SERVICE BULLETIN

SB-10056035-5082

SPORTSTER CHROME HAND CONTROL LEVER - SAFETY RECALL CAMPAIGN 0156

Figure 1. Hand Control Lever

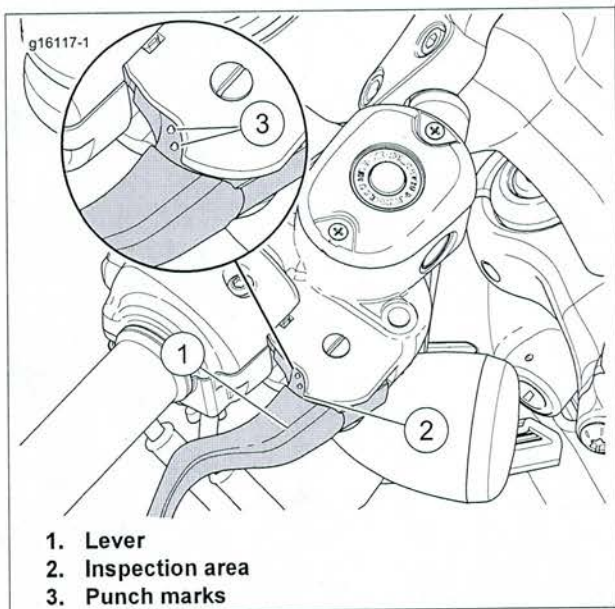
1. See Figure 1. Squeeze the front brake lever (1) and observe area (2).
2. If two punch marks (3) are present, lever is not involved in recall. If the two punch marks are not present, replace lever with recall kit.

Figure 2. Recall Kit Installation

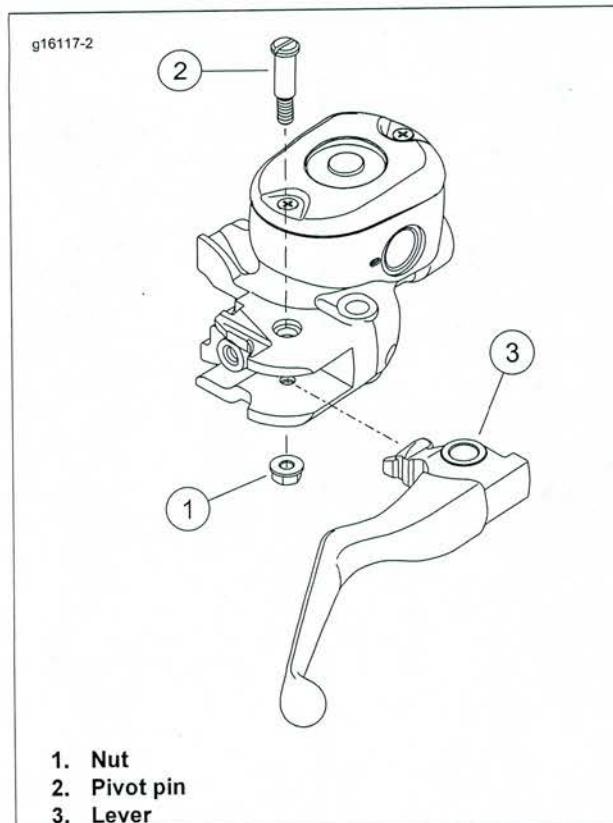
The affected kits have a package date that is earlier than 5/08/2014. Some of these accessory kits may contain brake levers with excessive chrome plating. In extreme cases this could prevent complete return of the master cylinder piston. If the piston cannot completely return and uncover the port-timing hole, fluid pressure will not be relieved. If this condition remains undetected, it could cause the fluid pressure to increase, possibly resulting in a front wheel lock-up, which could lead to a crash.

1. See Figure 2. Remove the nut (1) and pivot pin (2).
2. Remove the brake lever (3).
3. Lubricate the brake lever pivot pin hole and bushing with G40 BRAKE GREASE (Part No. 42820-04).
4. Install the **new** brake lever included in the recall kit.
5. Install the pivot pin. Tighten to 5-13 **in-lbs** (0.5-1.5 Nm).
6. Install the pin nut. Tighten to 44-61 **in-lbs** (4.9-6.9 Nm).
